Exhibit Number:	:	<u>SED-40</u>
CPUC Proceeding	:	<u>H.25-07-005</u>
Sponsor	:	<u>SED</u>
Witness	:	<u>Ed Pike</u>
Date Ident.	:	<u> </u>
Recd.	:	<u> </u>
Admin. Law Judge	:	<u>Gerald F. Kelly</u>

SAFETY ENFORCEMENT DIVISION
California Public Utilities Commission

PacifiCorp Responses CA 2021-WMPs
SED Set 3 (1-14)

Re: CA 2021-WMPs
CPUC SED Set 3 (1-14)

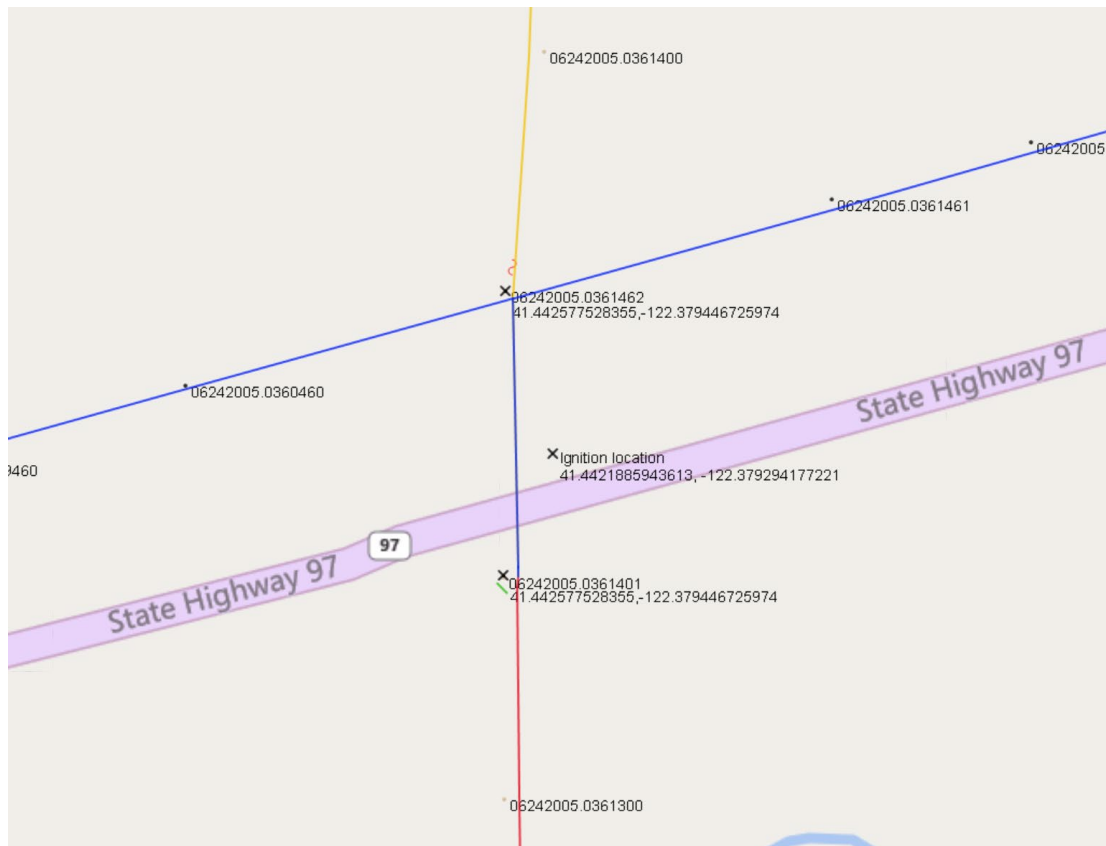
PacifiCorp's response to SED-01 Q3 states that a fire occurred March 4, 2021, within one quarter mile of circuit 5G83 segment 8077663 due to "Contact from object, External Force." PacifiCorp's response to SED-02 Q4 states "According to the incident notes, a vehicle made contact with a conductor where it crossed the road. The vehicle contact caused the wire to come down, which then caused the ignition."

- (a) State the latitude and longitude of the two poles of segment 8077663 closest to the ignition origin.
- (b) State the distance of segment 8077663 from the ignition origin.
- (c) Confirm that the section of segment 8077663 closest to the ignition was scheduled for replacement with the rest of segment 8077663. If not scheduled, explain why this location was not included in the segment 8077663 covered conductor installation.

- (a) Please refer to the table below which provides the latitude and longitude information of the poles of segment 8077663 closest to the ignition origin:

Pole number	Latitude	Longitude	GhIDs	Approximate distance
06242005.0361462	41.442577528355	-122.379446725974	8003684 8003685	150'
06242005.0361401	41.4419254229258	-122.379451783595	8003684 8077663	110'

Please refer to the figure below which provides the location of the ignition origin relative to the circuit segments and poles referenced in the table provided above:

- Blue line is segment 8003684
- Yellow line is segment 8003685
- Red line is segment 8077663

(c) Please refer to the map provided in the Company's response to subpart (a) above. Segment 8003684 included the conductor closest to the reported ignition as well as replacement of both poles nearest to the ignition. Segment 8077663 included the conductor from pole 0624005.0361401 south to pole 06242005.0361300 and into the residential neighborhood to the south. Both segment 8003684 and segment 8077663 are fully within Tier 2. Segment 8003684 was set as a higher priority because it is the electrical source for the area served by segment 8077663 and generally had greater exposure to vegetation.
